What this review needs to decide

The owner needs an accurate, simple backing-plate design that can be quoted and physically tried soon. Pro should issue concrete instructions to the local agent for revised CAD and separate fabricator, repair and installation handoffs.

Main: diameter 220 mm, centered upright capsule 116.35 x 151.10 mm, end radius 58.175 mm. Diverter: 124 mm outside / 80 mm inside; 120 mm fallback. Stock: 1.524 mm metal or matching plastic; separate 3 mm plastic trial. No locators in the present files.

Current main aperture

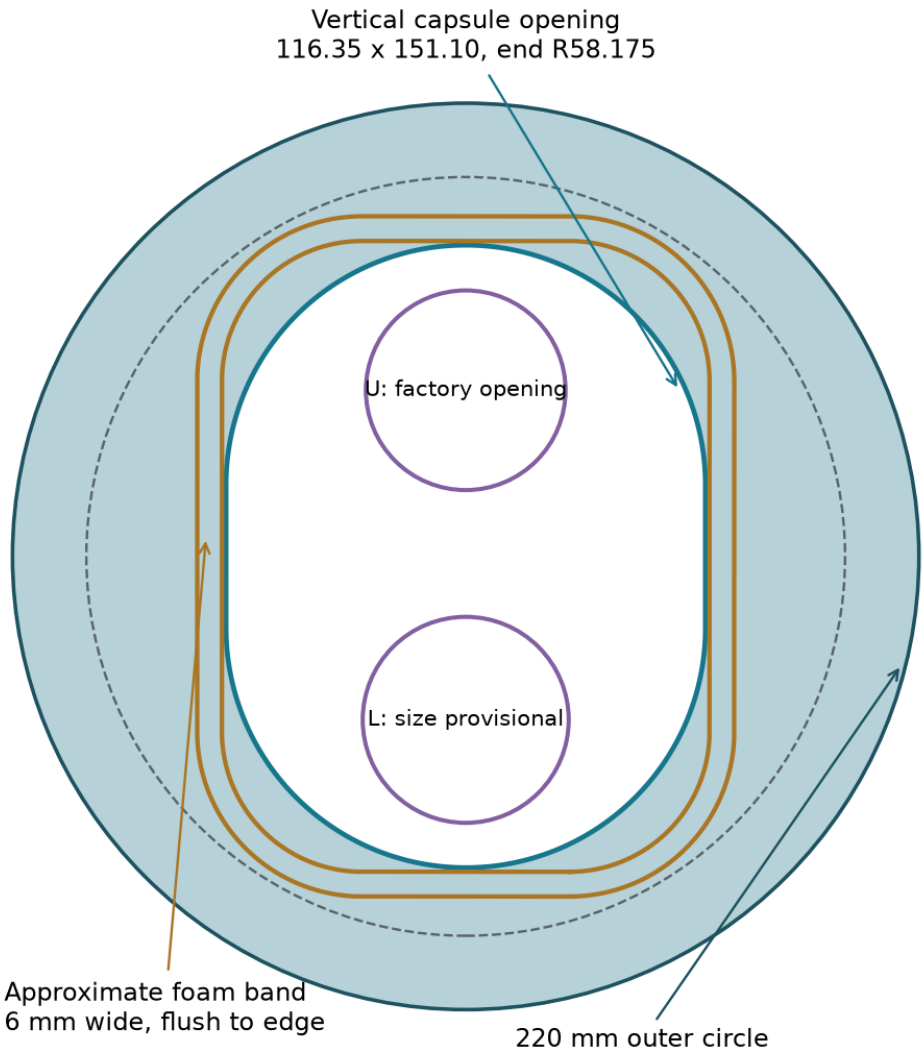
Gold is a nominal footprint, not a verified seal. Only 1 mm extra land inside the assumed foam.
Purple circles belong to the factory inner plate; they are not extra holes cut in this part.

Main outside diameter 220 mm; centered vertical capsule 116.35 x 151.10 mm with R58.175 ends. Gold represents assumed edge-flush foam. The lower opening circle and some placement dimensions remain assumptions.

The nominal extra land inside the 6 mm foam is only 1 mm. The smallest scoped projected hardware clearance is about 1.61 mm before unresolved scan/placement errors. These are review targets, not accepted field tolerances.

Main and diverter size choice

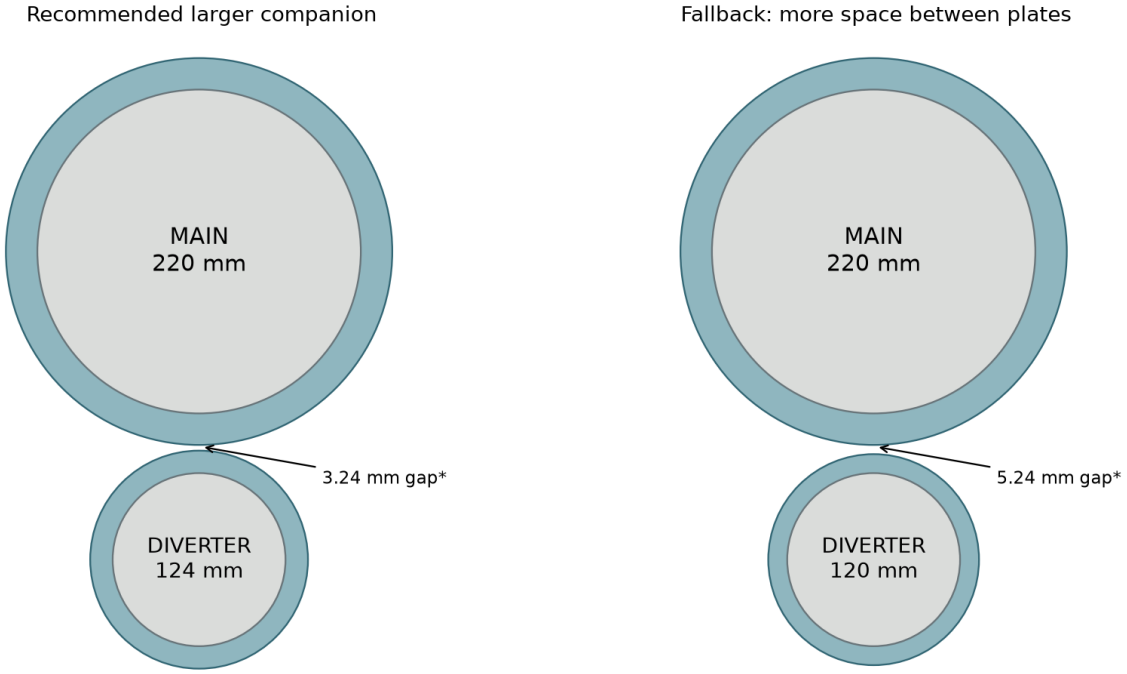
*Original placement estimate. Recentered scale trial gives 5.21 / 7.21 mm. These are scenarios, not bounds. Increasing either diameter consumes half that increase from the gap. Verify with both real covers.

Earlier placements predict only about 3-5 mm between the larger pair. These are scenarios, not an uncertainty range. The actual diverter seal footprint and paired clearance need the expert fit trial.

Recommended trial: main 220 mm and diverter 124/80 mm. The separate diverter fallback is 120/80 mm. Keep both backing circles concentric with their actual covers.

Earlier locating-tab experiment

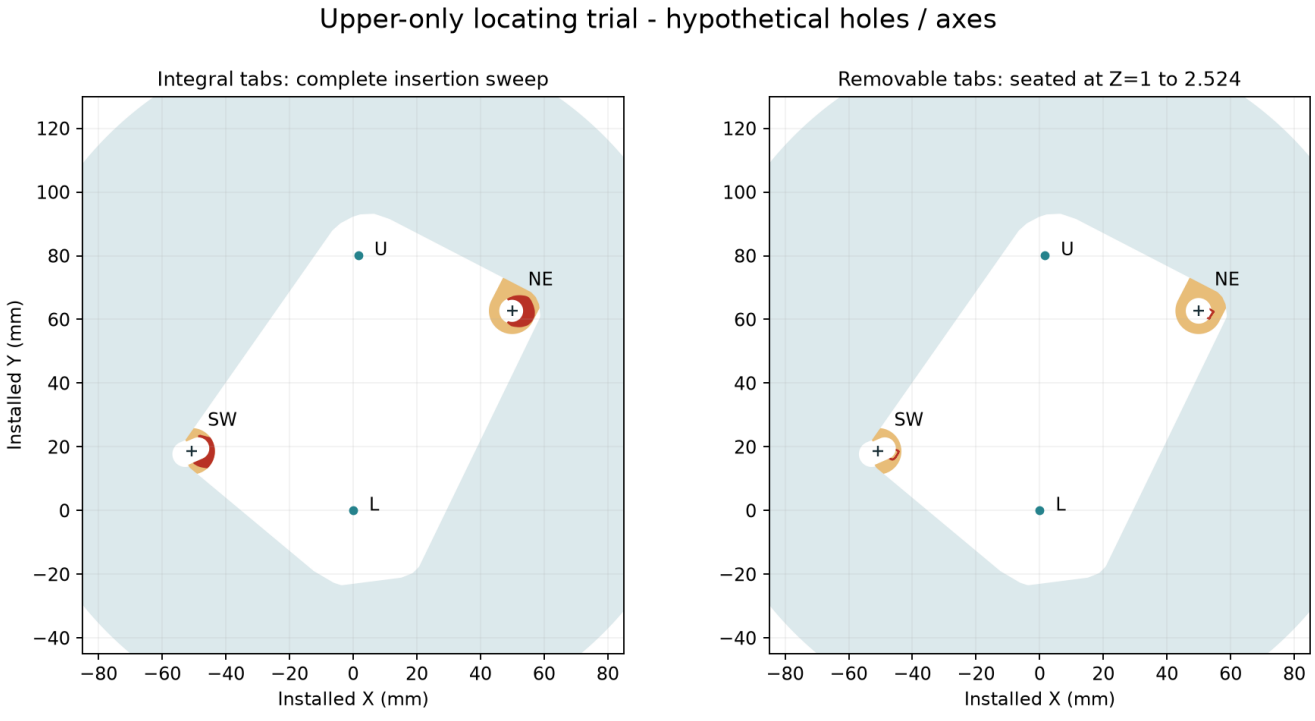
Amber: added tab metal. Red: projected captured-surface interference. Not a released mounting design.

This earlier diagonal opening added metal tabs with hypothetical holes/axes. Red marks conditional captured-surface interference in insertion or seated trials. It is not the FT01 capsule design.

The trial does not rule out every notch. A notch removes material; a tab adds it. Pro should independently assess restraint, adjustment, foam land, bearing, depth and complete insertion/removal before recommending a locator variant.
